# Access Compliance Report

### (Curb Ramps)

Intersection ID: 23773	Main Street: CANDLEWYCK_LN	Cross Street: REA_RD	Location:	E
ADA ID: 7A71655B7097	Ramp Type: Perp	Initial Pass/Fail: Fail	Overall Compliance: No	Severity Score: 12.5
Codes/Mitigation Info/Possible Solution		Field Measurements/Component Compliance

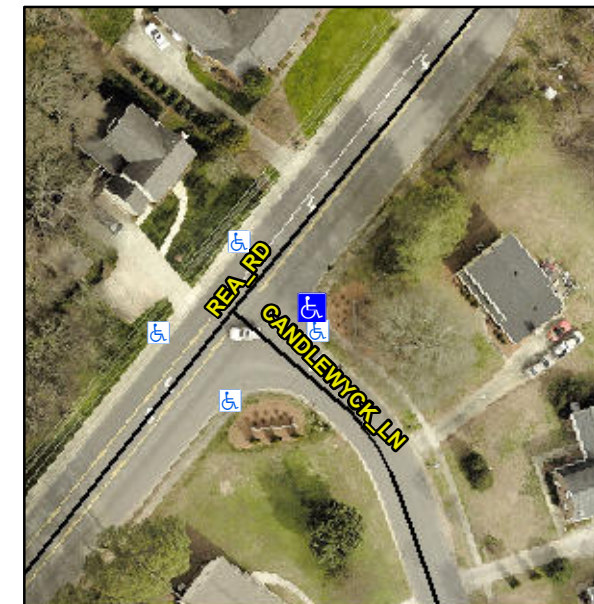
**Not Found, R304.2.2**

Compliance	Description	Data	Compliance	Description	Data
N/A	Ramp Length (in)	72.0	No	Ramp Slope (%)	9.3
Yes	Ramp Width (in)	48.0	Yes	Ramp XSlope (%)	1.8
N/A	Flare Type LT	N/A	N/A	Flare Type RT	N/A
N/A	Flare Slope LT (%)	N/A	N/A	Flare Slope RT (%)	N/A
N/A	Flare Traversable LT?	N/A	N/A	Flare Traversable RT?	N/A
N/A	Landing Length (in)	N/A	N/A	DWS Provided?	N/A
N/A	Landing Width (in)	N/A	N/A	DWS Contrast?	N/A
N/A	Landing Slope (%)	N/A	N/A	DWS Length (in)	N/A
N/A	Landing X Slope (%)	N/A	N/A	DWS Full Width?	N/A
N/A	Landing Curb? (Y/N)	N/A	N/A	DWS Offset (in)	N/A
N/A	Shared Landing?	N/A			
N/A	Gutter Ponding?	N/A	N/A	Gutter Slope (%)	N/A
N/A	Gutter Lip Ht (in)	N/A	N/A	Gutter X Slope (%)	N/A
N/A	Painted X Walk1?	No	N/A	Painted X Walk2?	N/A
	X Walk 1 Direction	To NW		X Walk 2 Direction	N/A
N/A	X Walk 1 Width (in)	N/A	N/A	X Walk 2 Width (in)	N/A
	X Walk 1 Slope (%)	1.7		X Walk 2 Slope (%)	N/A
	X Walk 1 X Slope (%)	0.5		X Walk 2 X Slope (%)	N/A

**Remove & Replace Entire Ramp.**
